**Project Name: Site Plan & Design Review**  
**Dollar Tree**  
**4008 Okeechobee Road**

The following is a response to staff comments dated: July 18, 2017 below are the comments along with our responses in bold:

**RE : Dollar Tree Site Plan – 4008 Okeechobee Road  
TRC No. 17-07000003**

**SUBJECT: Site Plan & Design Review  
Dollar Tree  
4008 Okeechobee Road**

**5) Tree Preservation / Disposition Plan Proposed: "83 Inches to Remain / 57 Inches to be Removed"**

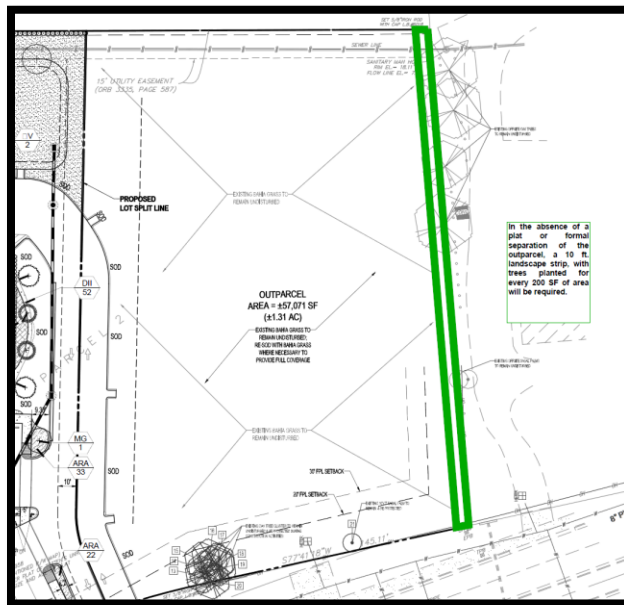
- The development site includes two parcels of land previously cleared, with "Parcel 1" previously developed with two single family homes which places the property as previously disturbed or developed, therefore the trees remaining may have previously been utilized for tree credits.

- Further, the plan seeks to utilize a cluster of oak trees with DBH ranges from 2 -4 inches, however the trees are located in a tight cluster therefore several of the sought for preservation do not meet the requirement of City Code Section 22-194 (d) (3), as the eight (8) trees as there's not the capacity to appropriately grow and develop due to their close proximity to each other, pursuant to City Code Section 22-194 (3) *The replanting design shall provide adequate space for root and crown development;*. There's currently no considerations to attempt to relocate or replant these oaks elsewhere on site.

- The plans call to remove a 23" live oak which exists along the proposed driveway. Staff encourages further review to determine if feasible to construct along or around this oak without significant damage to the tree, while allowing for pruning to provide appropriate vehicle entry/clearance into the site.

- Based upon review of proposed removal/preservation of trees on-site, it appears that the plan calls to remove 57 inches (and 1 palm) and preserve 53 Inches.

**Response: Acknowledged; While trees to remain may have previously been utilized for tree credits, only Existing Tree #3 is being utilized as part of this new development's landscape calculations for minimum tree requirements, while other existing trees to remain on site are utilized towards mitigation requirements, or are not counted at all towards on-site requirements at this time (as in the case of tree cluster to East of driveway off of Okeechobee Road).**

**Response: Tree cluster East of driveway off of Okeechobee Road is not being affected by construction, & there is no current plan for development at the East outparcel, therefore said tree cluster shall remain preserved & protected. Since the future disposition of this tree cluster is yet to be determined (as they may be removed at a later time for second Outparcel development), none of trees in cluster are counted towards the minimum landscape requirements for this site at this time.**

**Response: Upon further review, it has been determined by the Landscape Architect that 23" dbh Live Oak Tree # 12 cannot be preserved due to its location along proposed parcel lines that impedes the construction of a central drive aisle which is critical to the development of this dual-parcel site. An oak this size possesses a 23' Critical Root Zone radius from the center of the trunk, in which any construction within this area could potentially jeopardize the survival & structure of this tree. To ensure functional use of this property, Tree #12 is to be removed & mitigated accordingly. See sheet L-1 Disposition Plan.**

**Response: Current Disposition Plan, sheet L-1, proposes the removal of 23" of Live Oak dbh & preserves 117" of dbh, including Tree#3 counted towards on-site landscape requirements. No palms are proposed for removal at this time. 99" of Preserved Tree dbh on-site exceed code minimum & count towards the mitigation requirement for this submittal.**

Hartman Road Elevation

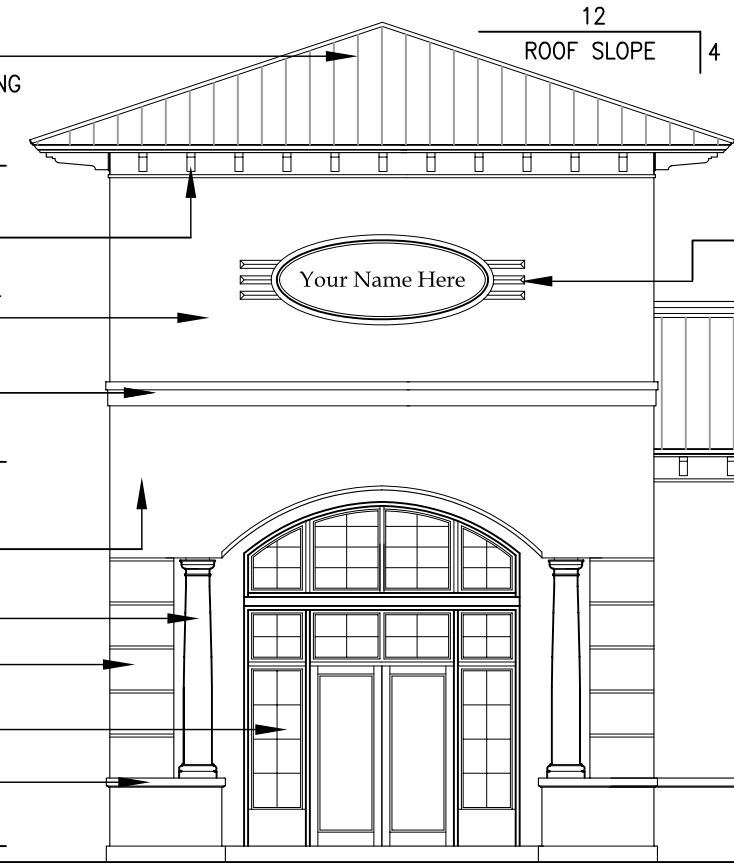
e. **Large expanses of wall without windows or detail that face the public right-of-way are prohibited (Hartman Road Elevation).** Retail buildings shall have fenestration that reveals interior activity and encourages interest in the products or services provided.

The west elevation of the structure is not consistent with our design review guidelines. Further, as the applicant has selected Hartman Road as the "main street" for the frontage line, further articulation of this façade is required.

**Response: This façade has been revised to incorporate embellishments to enhance the view from the street.**
